**TAC Meeting – May 12, 2008**  
**Announcements from the Chair**

San Luis Obispo County Wastewater Project Development  
TECHNICAL Memorandum  
Effluent Reuse and Disposal Alternatives  
Final Draft April 2008

**SUBJECT: EXPLANATION OF APPLICATION RATE FOR THE  
BRODERSON LEACHFIELDS, LOS OSOS  
WASTEWATER PROJECT**

Figure 1: Design Infiltrative Surface Application Rates

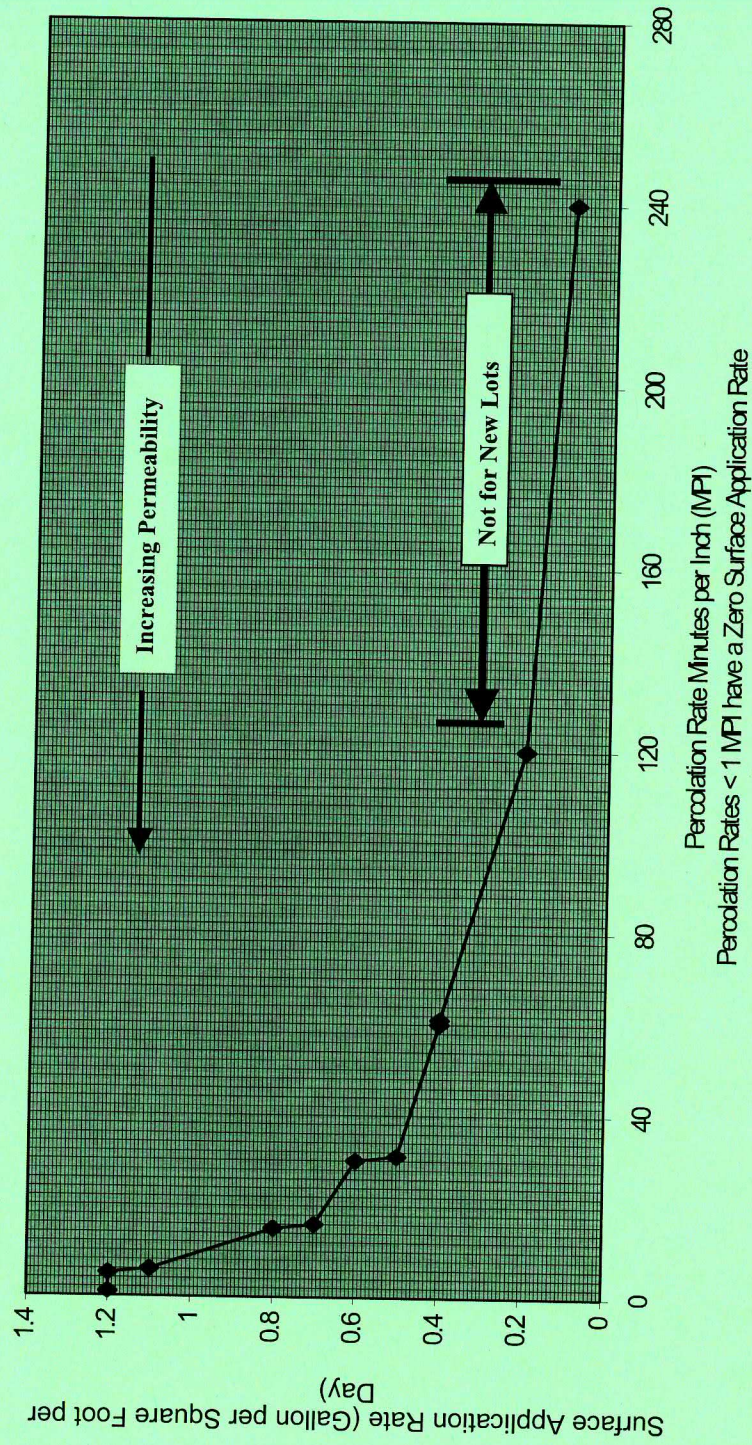
**Third**, the Broderson site percolation rate data in 2003 indicate all sites had percolation rates greater than one minute to percolate one inch of treated waste water. Table 2 and Figure 1 of the March 2007 draft law AB 885 says under these conditions, a maximum application rate is 1.2 gallons of treated waste water per day per square foot.

**What is the correct value?** 180, or 30, or 7 or 1.2?
